NOTICE OF INTENTION TO DRILL MONITOR/PIEZOMETER WELL

MONITORING WELL SCHEMATIC

KATCHER PROPERTY

RE: Request for Variance, Monitor Wells
Pima County, Arizona
Registration Numbers 55-581291 through 55-581295

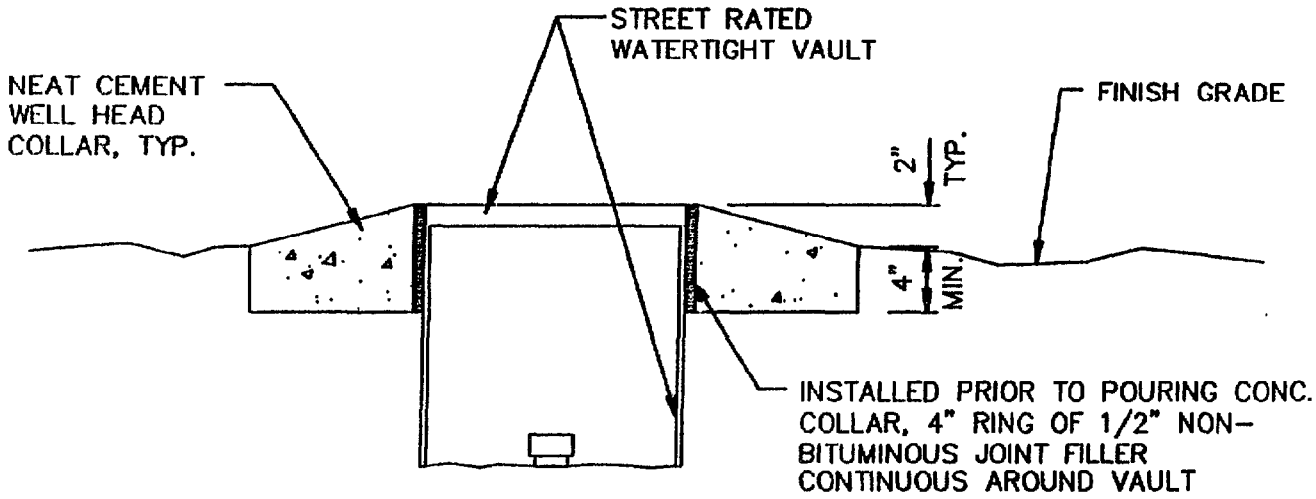
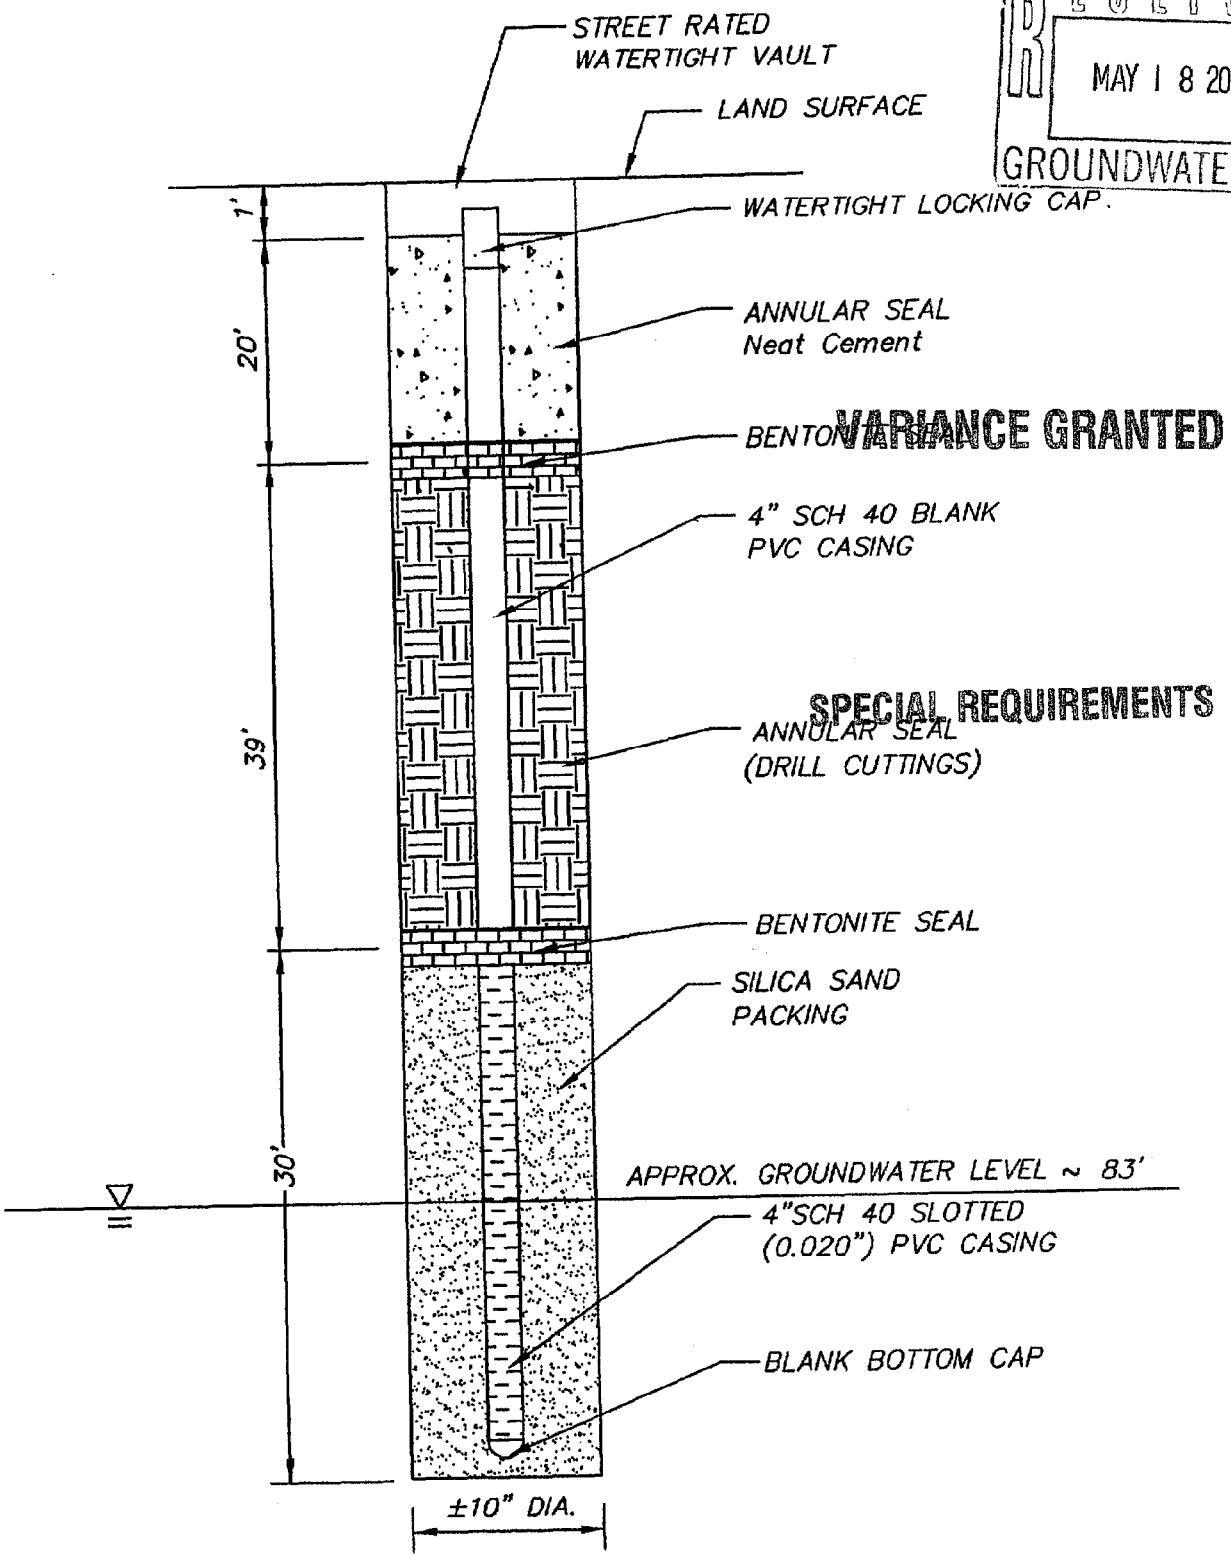
We are requesting the following construction variance from the provisions of section R12-15-811., "Minimum well construction requirements":

Sub-section B.1 , Surface Seal

* Thermoplastic (PVC) inner casing (riser) with a locking watertight cap will be used in lieu of steel surface casing. The riser will comply with ASTM Standard Guide D5092, Section 6.5.

Sub-section I. , Completion at the Surface

* The wells will be completed below the land surface in a flush-to-ground, vandalproof, traffic-rated vault per ASTM Standard Guide D5092, Section 8.9.2.3.

- A variance request to use thermoplastic casing with a watertight cap in lieu of steel
